CITY OF ALBUQUERQUE

RE: **109 Juan Tabo**
109 Juan Tabo NE
Drainage Report Stamp Date: 11/16/18
Grading Plan Stamp Date: 10/22/18
Hydrology File: L21D101

Based on the submittal received on 11/16/18, the Grading and Drainage Plan cannot be approved until the following are corrected:

APPENDIX A
SITE HYDROLOGY/
AHYMO MODEL

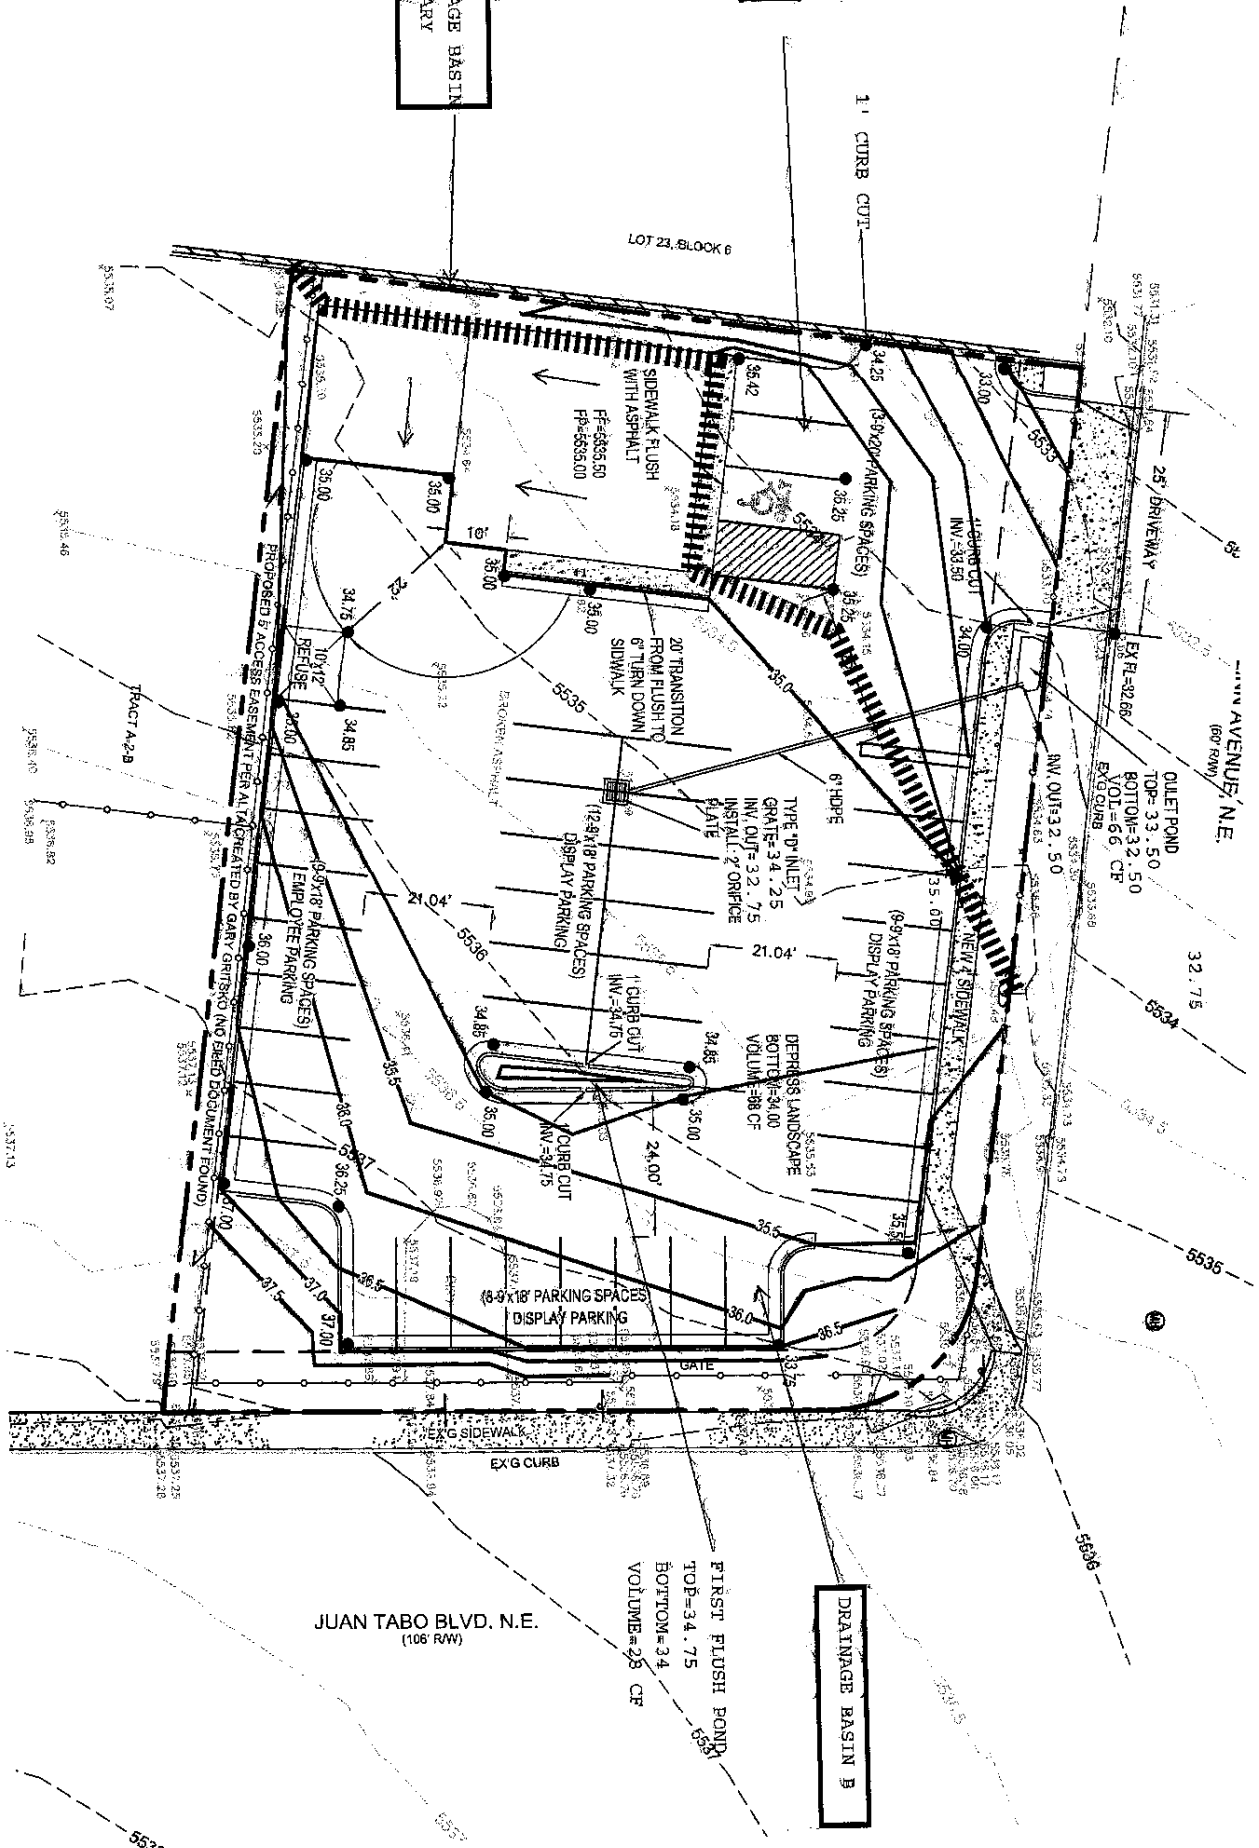
2. The Appendix A spreadsheet should be updated to reflect the above remarks. Also on the spreadsheet: the land treatment percentages for Basin B exceed 100%; this site is in precipitation zone 3, not 2.

4. A 2" orifice plate is specified on the grading plan, but the calculations were prepared for a 6" opening (Appendix A)

ENGINEER'S SEAL	109 JUAN TABO BLVD	DRAWN BY DEM
	GRADING AND DRAINAGE PLAN	DATE 10-22-18
	 1608 CENTRAL AVENUE SE SUITE 201 ALBUQUERQUE, NM 87106 (505) 972-0899	109 JUAN TABO.DWG
10/22/18		SHEET # C1
DAVID SOULE P.E. #14522		JOB #

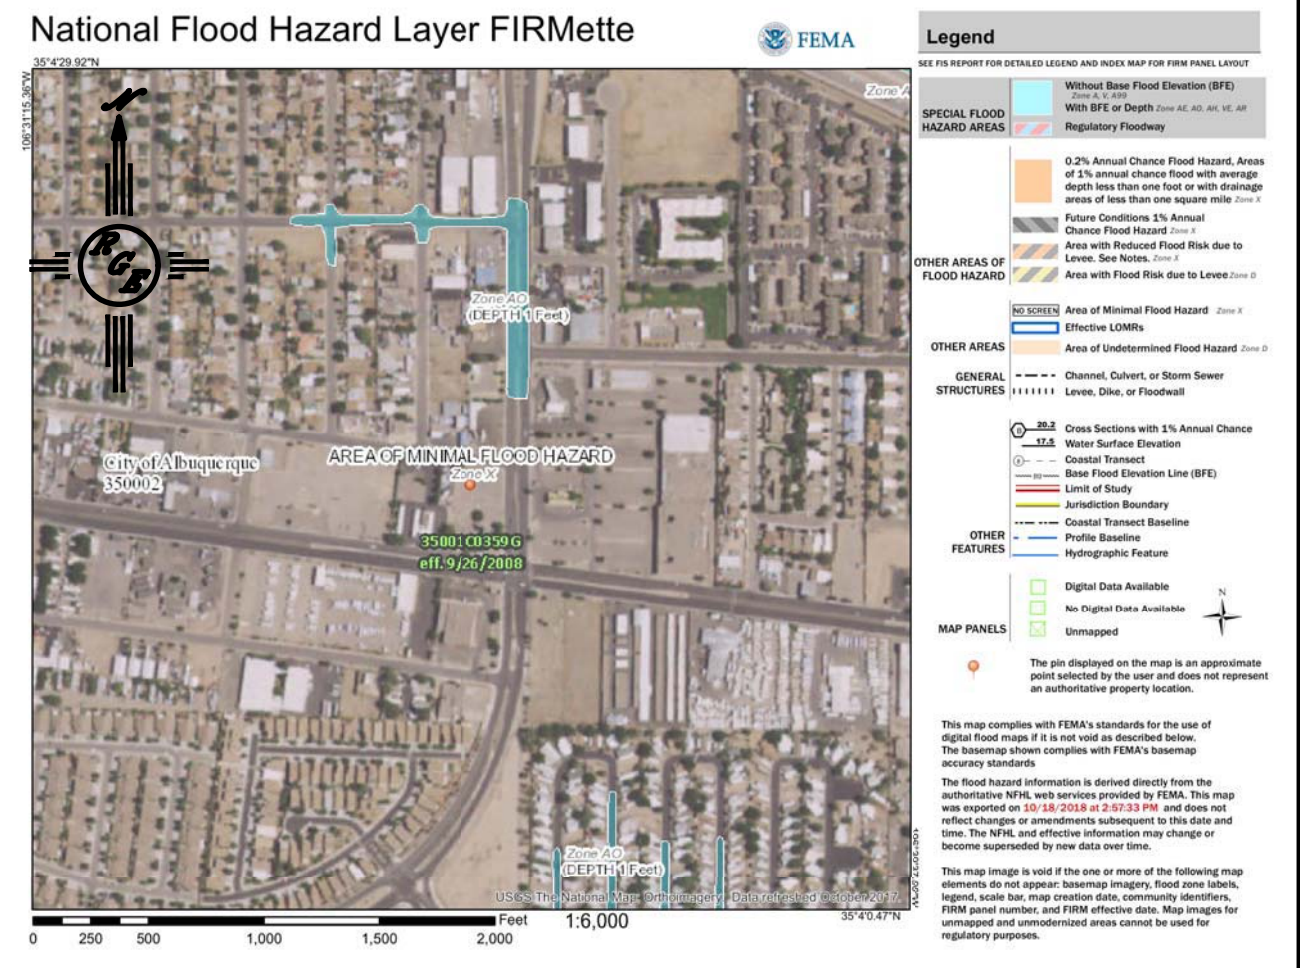
3. If requesting Payment-in-Lieu of the stormwater quality volume (SWQV) the plan must clearly state that Management Onsite of the SWQV could be provided, but the owner does not want to and wants Payment-in-Lieu of Management Onsite instead. Remove references such as "cannot pond onsite" and "required fee-in-lieu". The plan can be modified to accommodate Management Onsite and a Waiver of Management Onsite cannot be approved for this project.
